Proposed Amendments to the North Lotts & Grand Canal Dock SDZ Planning Scheme in relation to Building Heights.

North Lotts and Grand Canal Dock Planning Scheme 2014

Dublin City Council Oct 2019

City Block 2

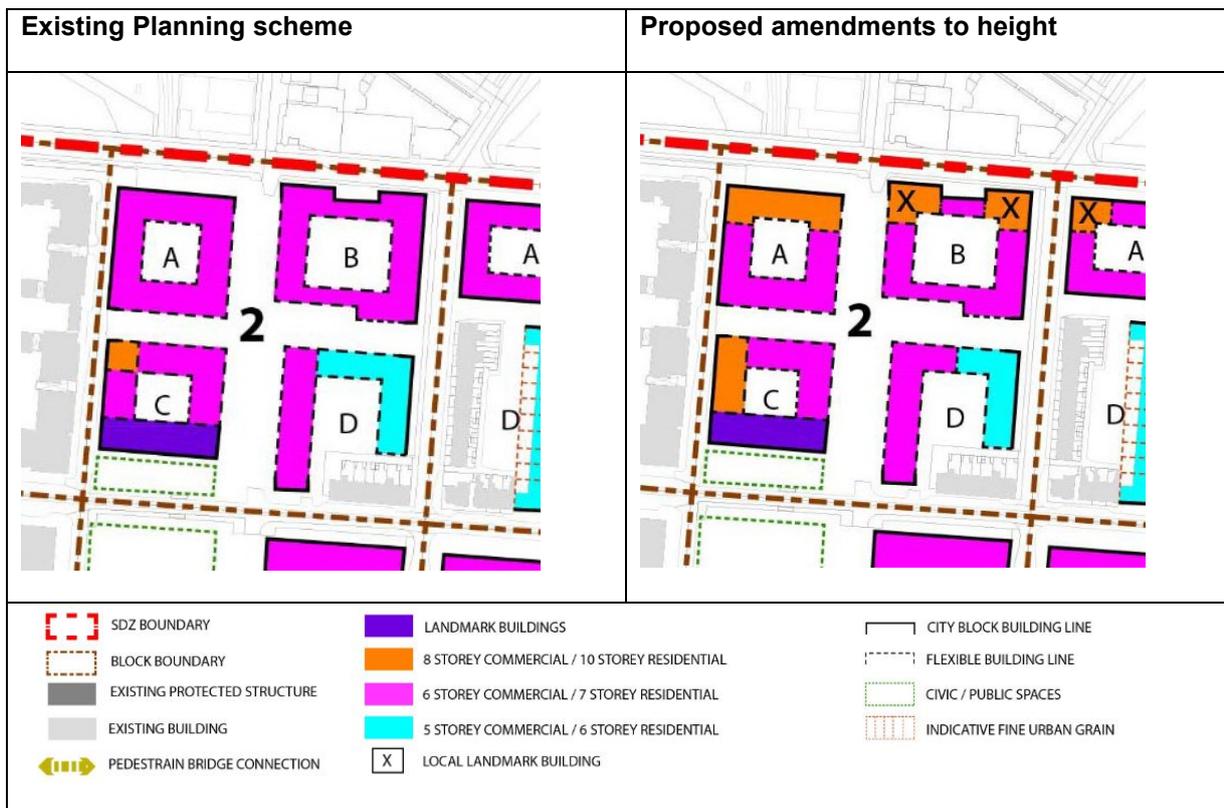
Page 183 Section 5.5.2, 2, 'Urban Form/Height Range' to be amended .i.e.

- **Block 2A to be 8 Storey commercial/10 storey residential fronting onto Sheriff Street Upper.**
- **12 Storey residential local landmarks at NE and NW corners of block 2B, to extend along no more than one third of the sub-block frontages.**
- Block 2C to be 12 storey (maximum) commercial (minimum 10 storey) fronting Station Square, to achieve balance between hub quantum and view lines from Georgian mile. Landscaped plaza south of block. **Western side of 2C to be 8 storey commercial/10 storey residential.**

- Remaining blocks to range between 5 storey commercial/6 storey residential and 6 storey commercial/7 storey residential, stepping down to 3 residential immediately north and west of the Mayor Street terrace.
 - Urban blocks to front Sheriff Street to remake and contain the street.
 - The 7 storey residential frontage to New Wapping Street responds to the 2/3 storey terrace opposite, more favourably than the 9 storey scheme previously certified.
- **Any temporary pavilion buildings to be up to a maximum of 4 storeys**

City Block 3

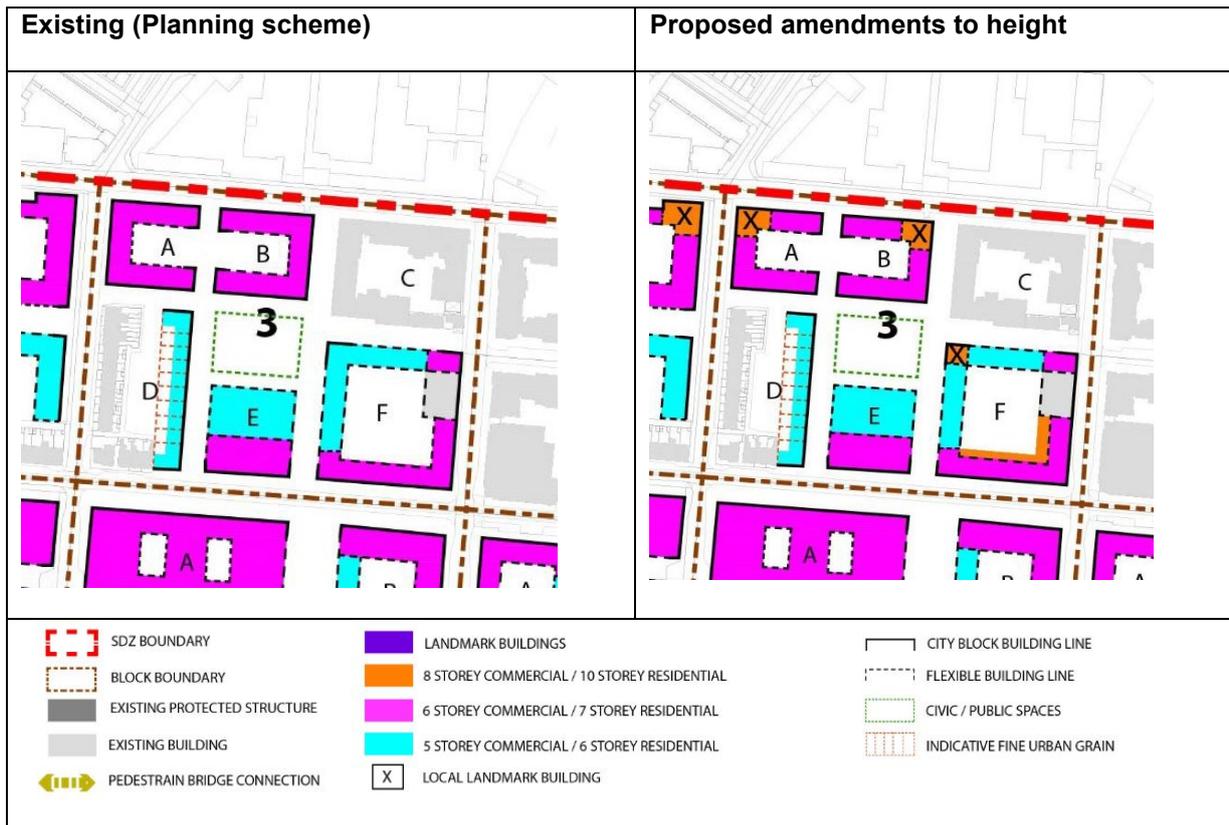
Page 184 Section 5.5.3, Urban Form/Height Range to be amended .i.e.

- Up to 7 residential/6 commercial provides strong perimeter to city block.
- **10 storey commercial/ 12 Storey residential local landmarks at corners 3A and 3B and must extend for no more than one third of the length of the sub-block frontages.**

- **3-4 storey residential** on block 3D to provide transition with existing 2 storey terraces, stepping down to 3 storey residential immediately east of the terrace on Mayor Street Upper and to the rear of the northern end of the terrace on New Wapping Street.
- **8 storey commercial/10 storey residential setback at 3F.** The North-west corner of 3F to provide a vertical modulation of up to 10 storey commercial/12 storey residential and must extend no more than one third of the length of the sub-block frontages.

City Block 11

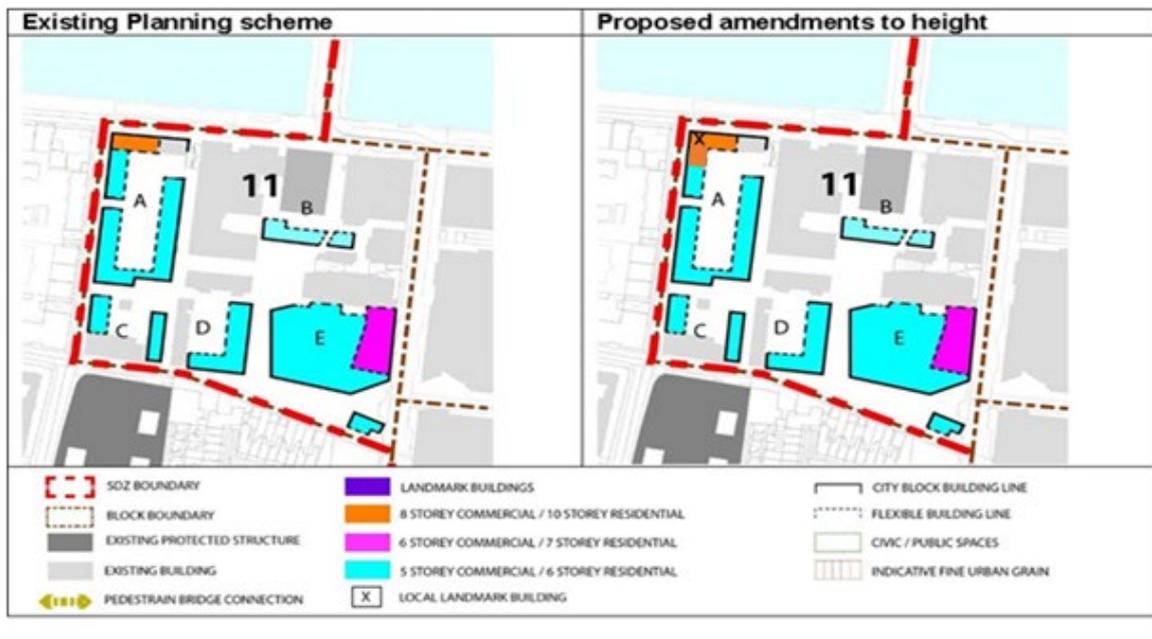
Page 198 Section 5.5.11, Urban Form/Height to be amended .i.e.

- Existing Protected Structures to be retained. New buildings fronting the northern side of the realigned (East-West) Misery Hill to be 5 storey commercial /6 storey residential; similar scale on

Lime Street. 11C to be 5 storey. New buildings along Sir John Rogerson's Quay (11A) may be up to 8 storeys commercial / 10 storeys residential subject to design criteria to safeguard the character of the adjoining protected structure.

- **10 storey commercial / 12 Storey residential local landmark at north west corner of 11A, to extend no more than one third of the length of the sub-block frontages**

City Block 18

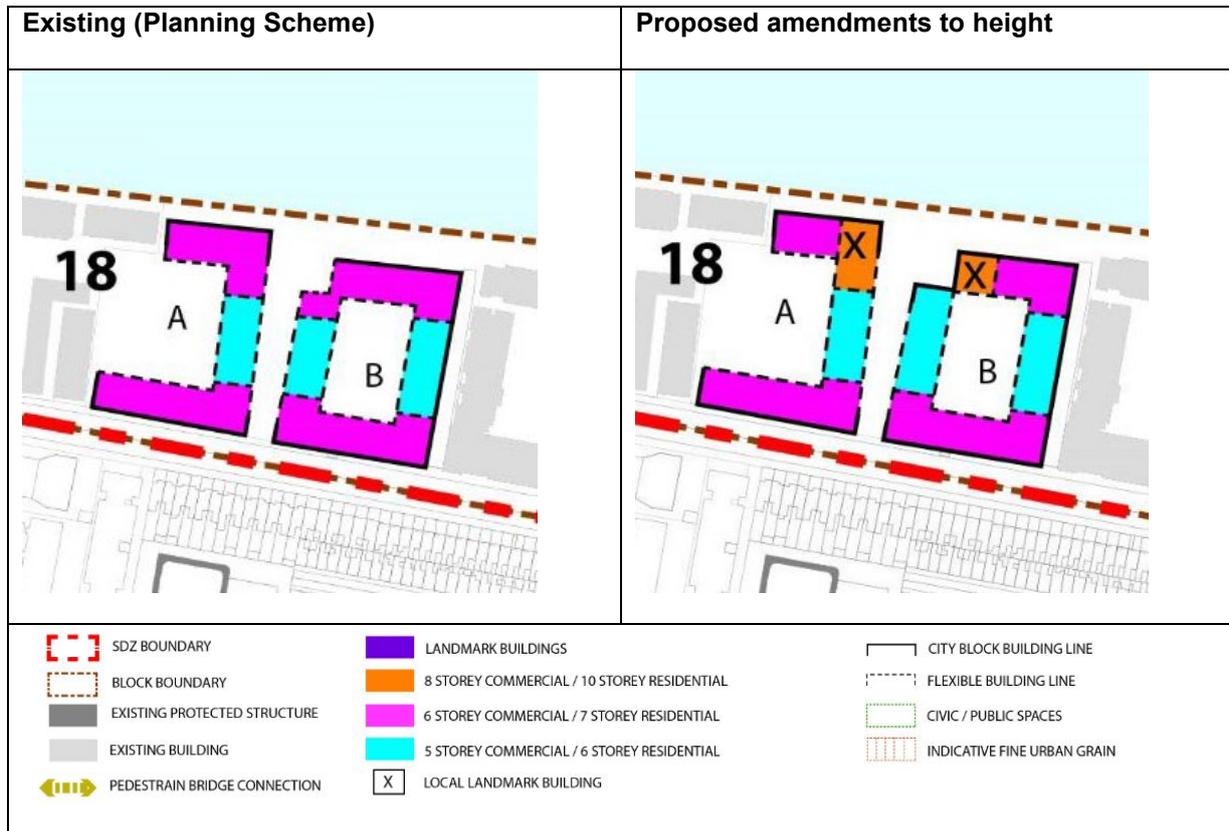
Page 211 Section 5.5.18, Urban Form/Height to be amended .i.e.

- 6 storey commercial / 7 storey residential along the water frontage to frame Grand Canal Dock and also along Ringsend Road to define the streetscape.
- **10 Storey residential local landmarks at corners of 18A and 18B, must extend for no more than one third of the length of the sub-block frontages.**

City Block 19

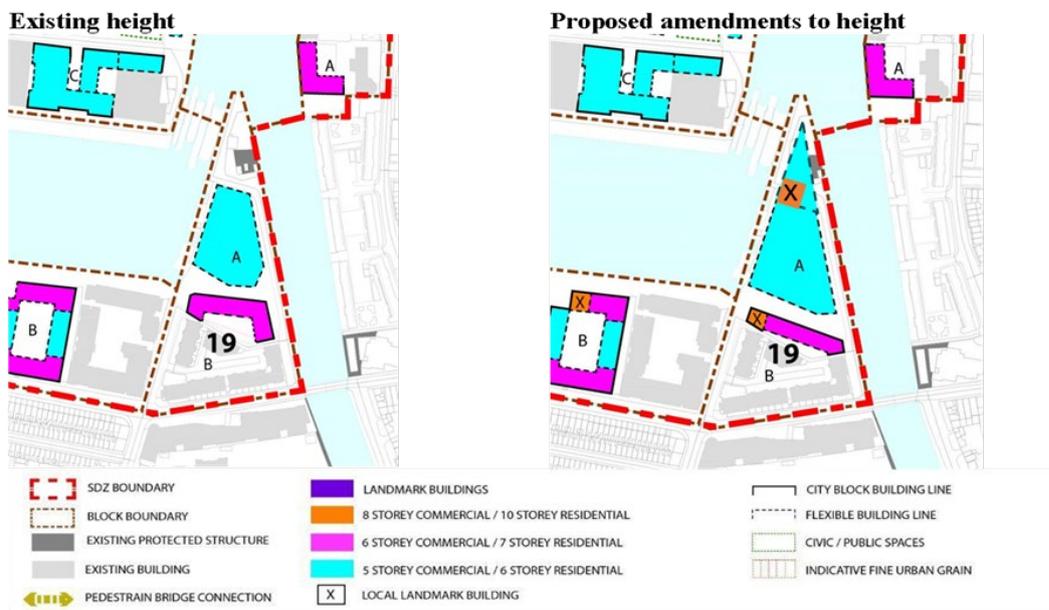
Page 213 Section 5.5.19, Urban Form/Height to be amended .i.e.

- Commercial / community buildings up to 5 storeys to contain the dock space. Residential perimeter block up to a maximum of 7 storeys to northern side of existing Camden Lock Development, subject to an appropriate transition in scale and design criteria which protects the residential amenity and minimises overshadowing of the Camden Lock Development.
- **8 Storey commercial/10 storey residential local landmark to north of Block A**
- **8 storey commercial/ 10 Storey residential local landmark at the western end of 19B, must extend no more than one third of the length of the sub-block frontage.**
